PROPOSED RESIDENCE AT:

325 VIA LINDA

DAILEY JANSSEN ARCHITECTS

ROGER P. JANSSEN AR-14785
ARCOM # ARC-23-014
TC # ZON-23-029

A-1.03

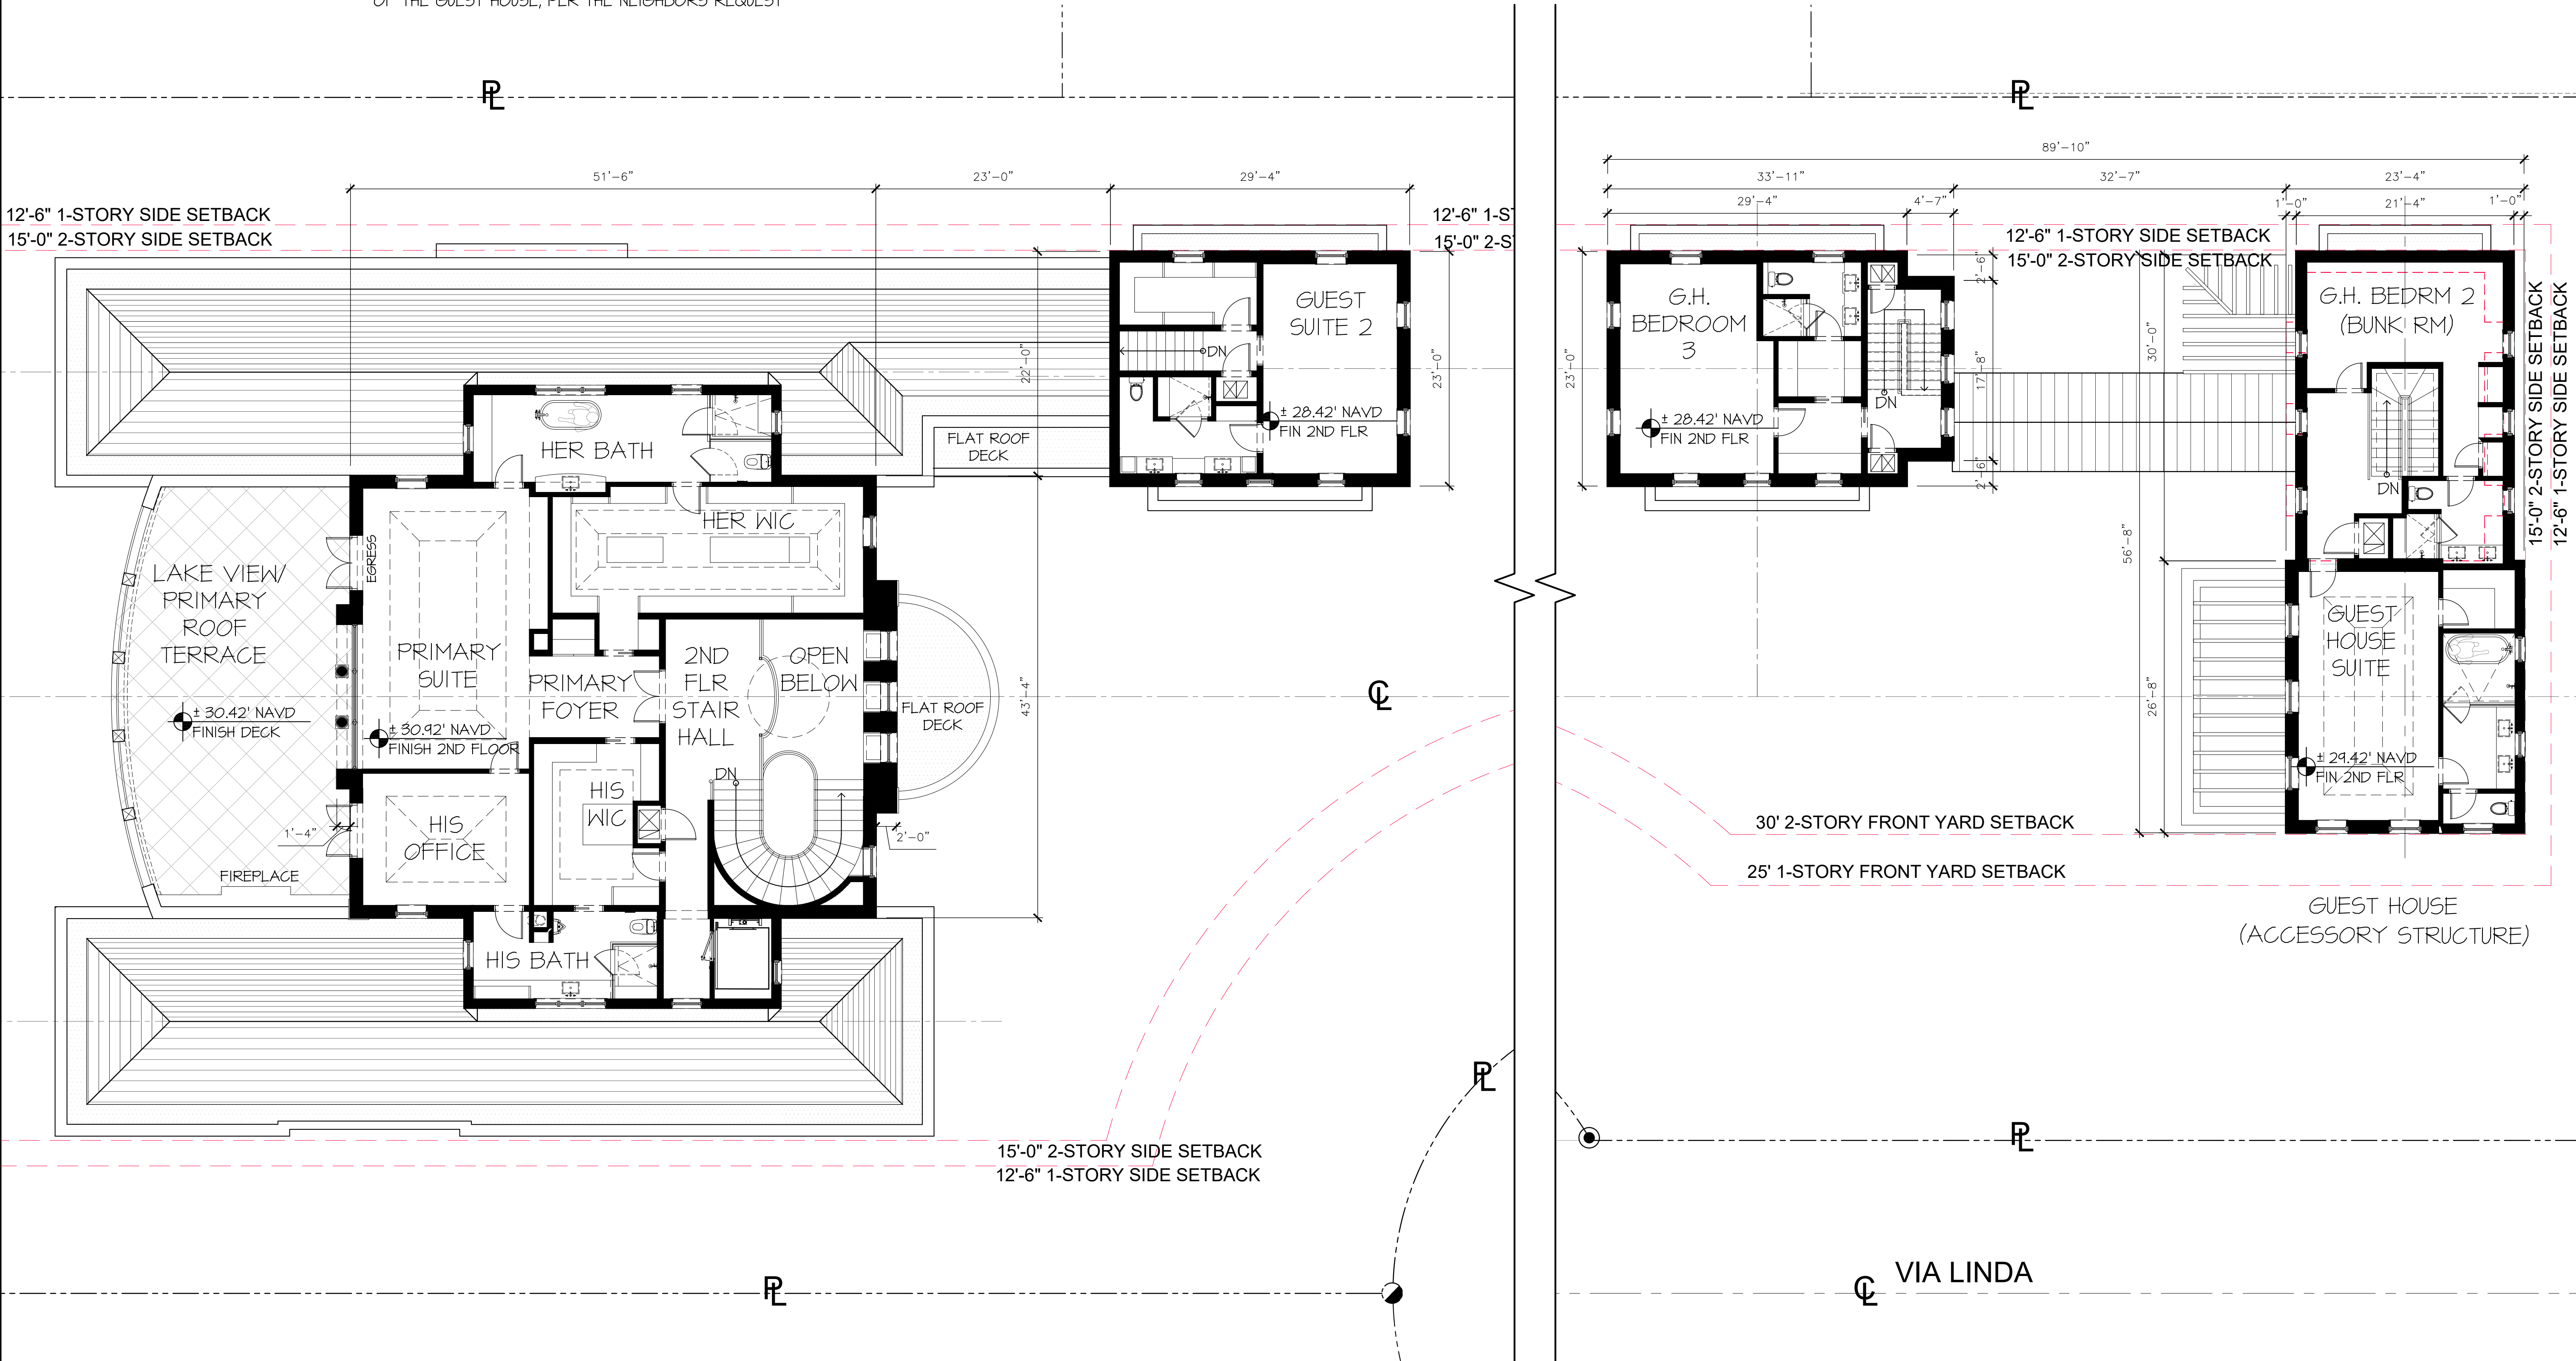
- REDUCTION OF 2ND FLOOR BAYS (NORTH AND SOUTH ELEVATION)
- REVISE 1-STORY ROOF PER FIRST FLOOR REVISIONS
- REVISE GUEST HOUSE PLANS, DUE TO ROOF REVISION
PROPOSED PARAPET WITH PITCHED ROOF IN LIEU OF MANSARD WITH DORMERS

A-1.04

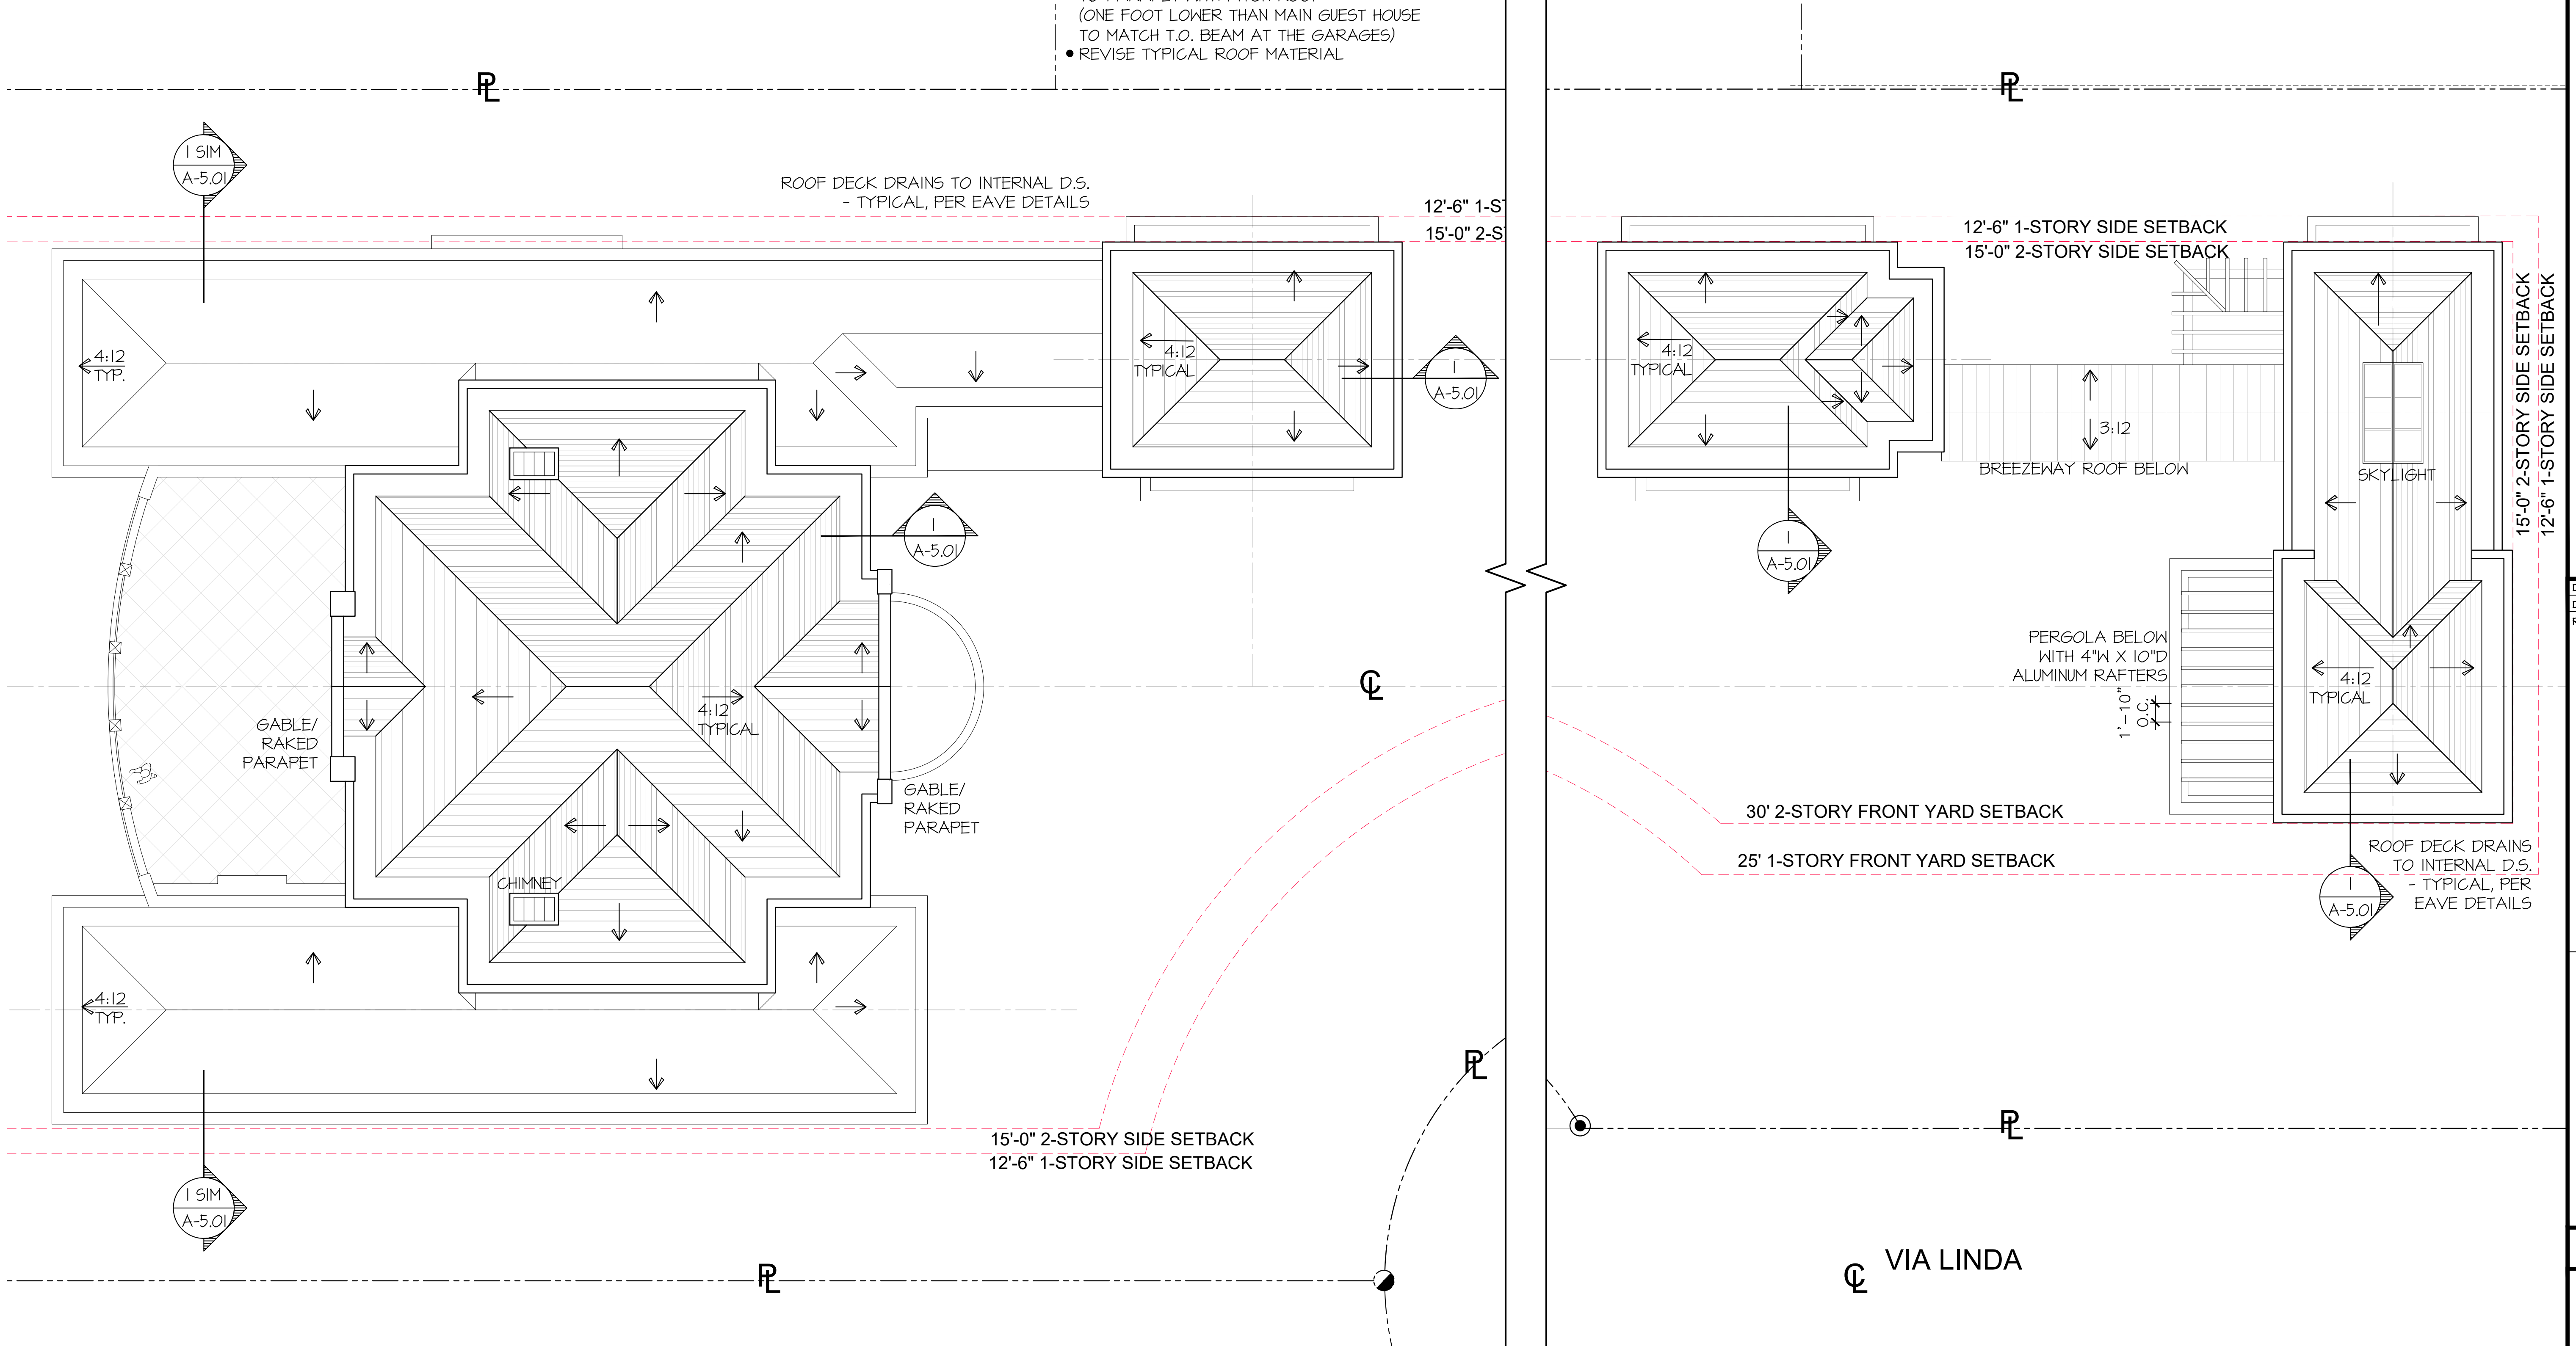
- REVISE ROOF PLANS
TYPICAL PITCH 4:12 (IN LIEU OF 6:12 AND 3:12) AND LOWER PARAPETS
- GUEST HOUSE (BUNK ROOM, NORTH END)
REVISE ROOF FROM MANSARD WITH DORMERS TO PARAPET WITH PITCH ROOF (ONE FOOT LOWER THAN MAIN GUEST HOUSE TO MATCH T.O. BEAM AT THE GARAGES)
- REVISE TYPICAL ROOF MATERIAL

A-2.03

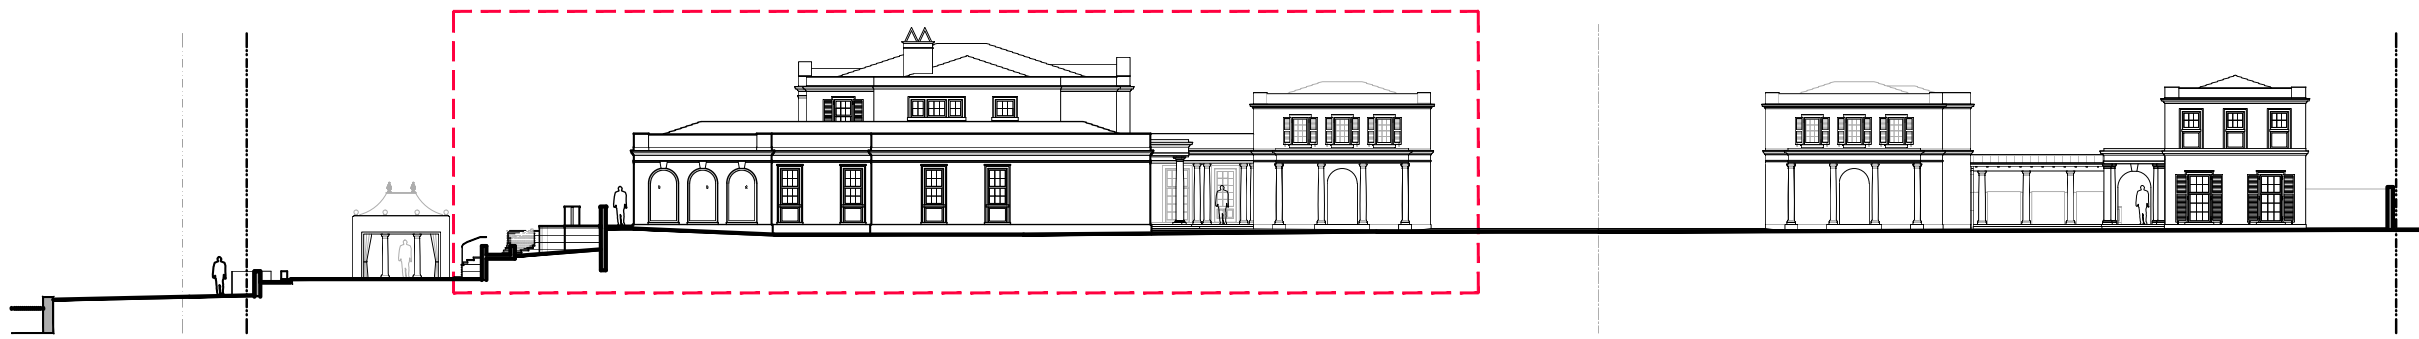
- CURRENT REVISIONS
- REDUCE WIDTH OF 1-STORY WINGS
 - REVISE STUCCO DETAIL WORK (CORNICES ETC.)
 - LOWER PARAPETS AND REVISE ROOF PITCH TO 4:12 (IN LIEU OF 6:12 AND 3:12)
 - LOWER ENTRY PORTICO
 - ELIMINATE BAY AT 1-STORY WING (MAIN HOUSE EAST ENTRY ELEVATION)

A-2.04

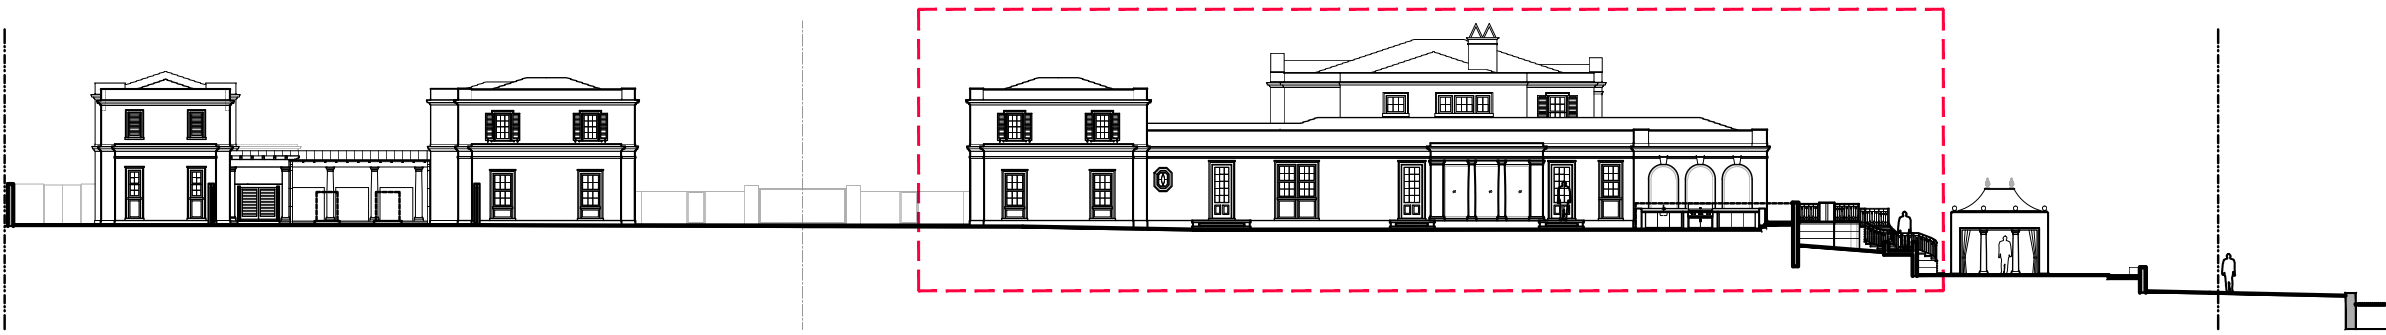
- REDUCE WIDTH OF 1-STORY WINGS
- REVISE STUCCO DETAIL WORK (CORNICES ETC.)
- LOWER PARAPETS AND REVISE ROOF PITCH TO 4:12 (IN LIEU OF 6:12 AND 3:12)

A-2.05

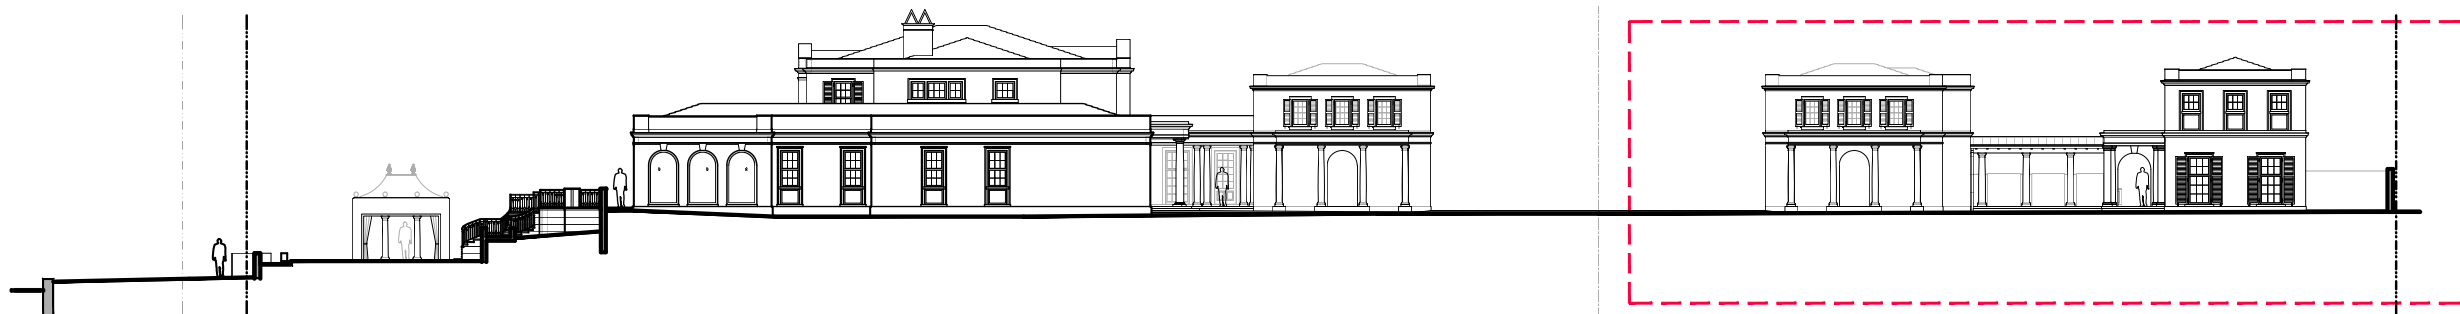
- REVISE STUCCO DETAIL WORK (CORNICES ETC.)
- LOWER PARAPETS AND REVISE ROOF PITCH TO 4:12 (IN LIEU OF 6:12 AND 3:12)

A-2.06

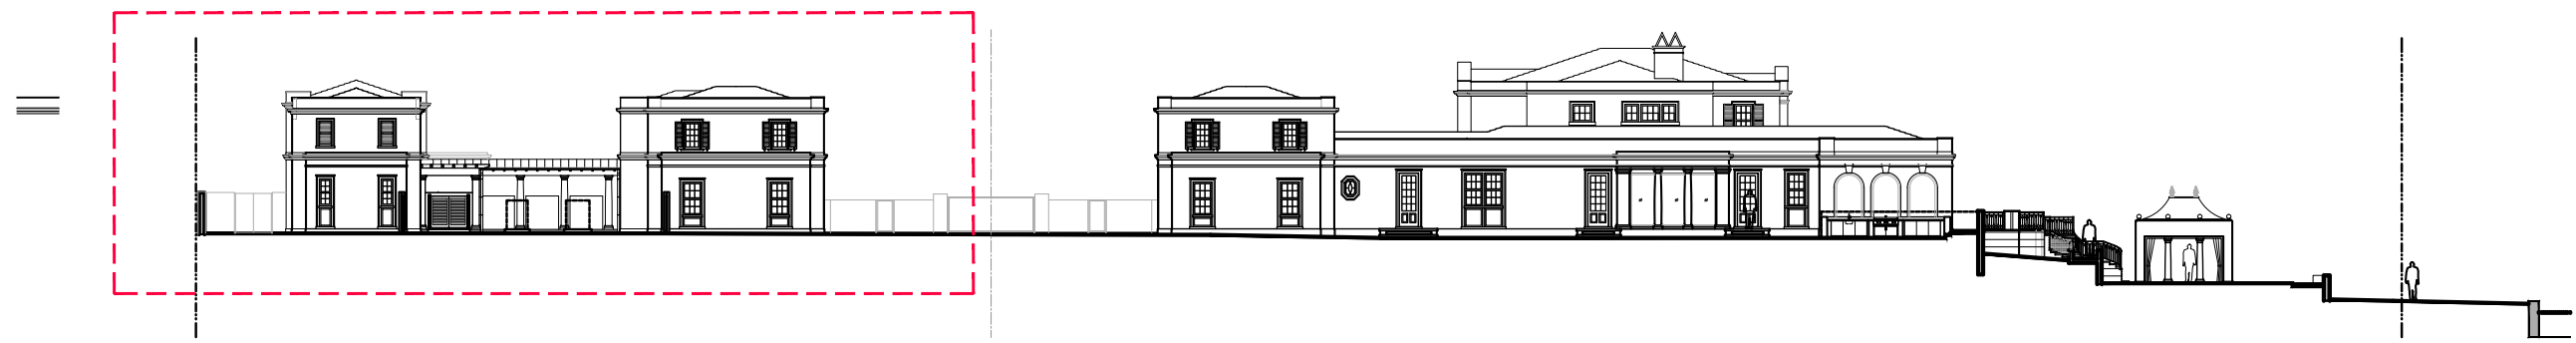
- REVISE STUCCO DETAIL WORK (CORNICES ETC.)
- LOWER PARAPETS AND REVISE ROOF PITCH TO 4:12 (IN LIEU OF 6:12 AND 3:12)
- GUEST HOUSE (BUNK ROOM) REVISE ROOF FROM MANSARD WITH DORMERS TO PARAPET WITH PITCH ROOF (ONE FOOT LOWER THAN MAIN GUEST HOUSE TO MATCH T.O. BEAM AT THE GARAGES)
- GUEST HOUSE 2ND FLOOR (BUNK ROOM) RECESSED SHUTTERS AT NORTH ELEVATION
- NO WINDOWS PER NEIGHBORS REQUEST

A-2.08

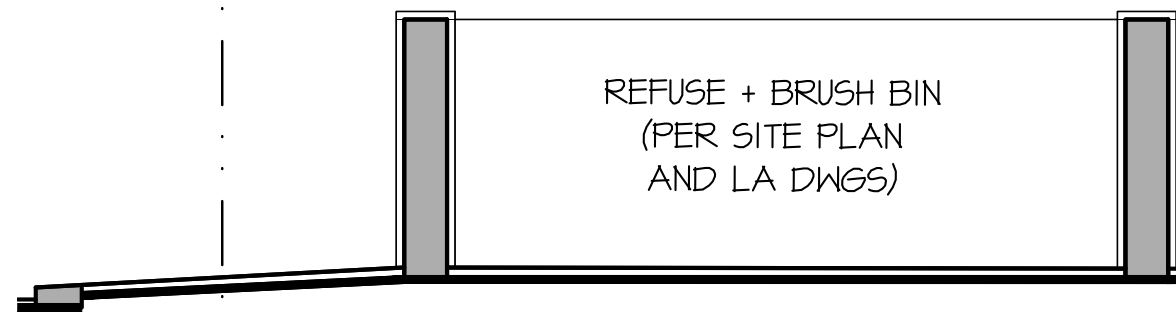
- REVISE STUCCO DETAIL WORK (CORNICES ETC.)
- LOWER PARAPETS AND REVISE ROOF PITCH TO 4:12 (IN LIEU OF 6:12 AND 3:12)
- GUEST HOUSE (BUNK ROOM) REVISE ROOF FROM MANSARD WITH DORMERS TO PARAPET WITH PITCH ROOF (ONE FOOT LOWER THAN MAIN GUEST HOUSE TO MATCH T.O. BEAM AT THE GARAGES)
